TECHNICAL BULLETIN
Bell Helicopter **TEXTRON**

No. 407-04-62
Date Dec 6, 2004
Page 1 of 4

MODEL AFFECTED: 407

SUBJECT: FREEWHEEL AFT SEAL LUBRICATION,
IMPROVEMENT OF

Figure 1. Instructions to extend the lubrication channel of aft bearing cap 406-040-509-101

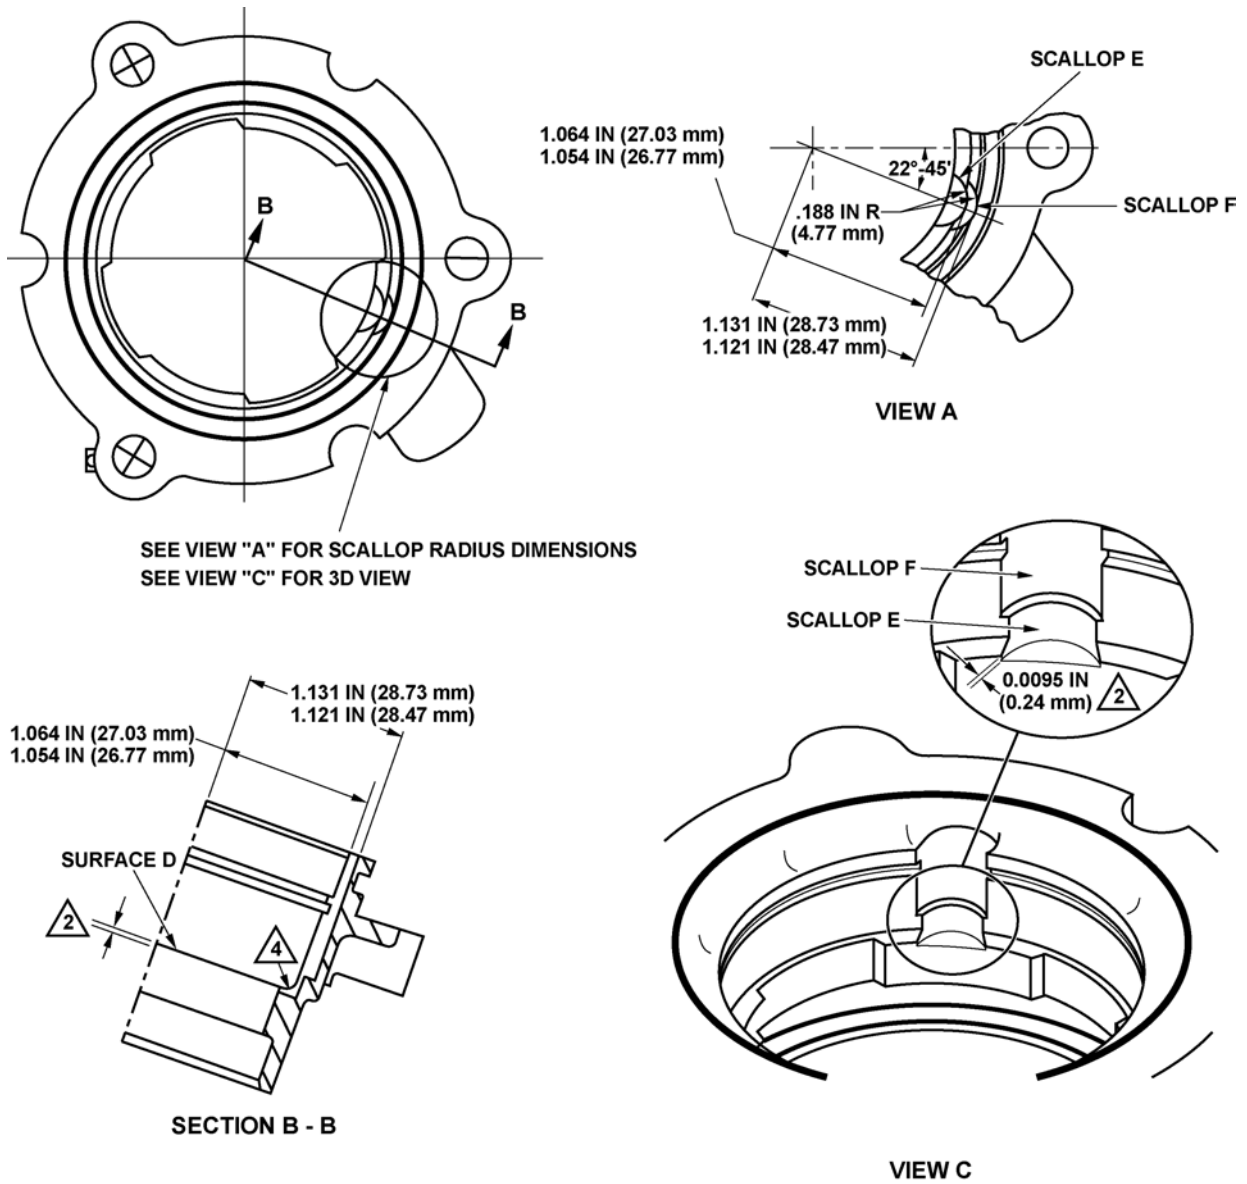
Bell Helicopter has determined that the freewheel aft seal lubrication is improved when a groove is machined in the bearing aft cap shoulder extending the lubrication channel. New bearing aft cap will not be reidentified with a different part number.

This bulletin gives instructions to rework the aft bearing cap 406-040-509-101 to latest configuration.

1. Locally modify the bearing aft cap as shown in Figure 1. Use a vibrating stylus to identify modified bearing aft cap by adding letter "FM" to the part number on the cap.
2. As an alternate, bearing aft cap may be send to Bell Tennessee for modification. Modified bearing aft cap will be identified be adding the letter "FM" to the part number. For advance scheduling, contact:

1. Surface finish to be 125 u inch RMS
2. Extend the machining of the scallop "E" 0.0095 inch (0.24 mm) ± 0.0025 inch (0.06 mm) below surface D.
3. Break all sharp edges.
4. Scallop radius 0.020 inch (0.508 mm) maximum.
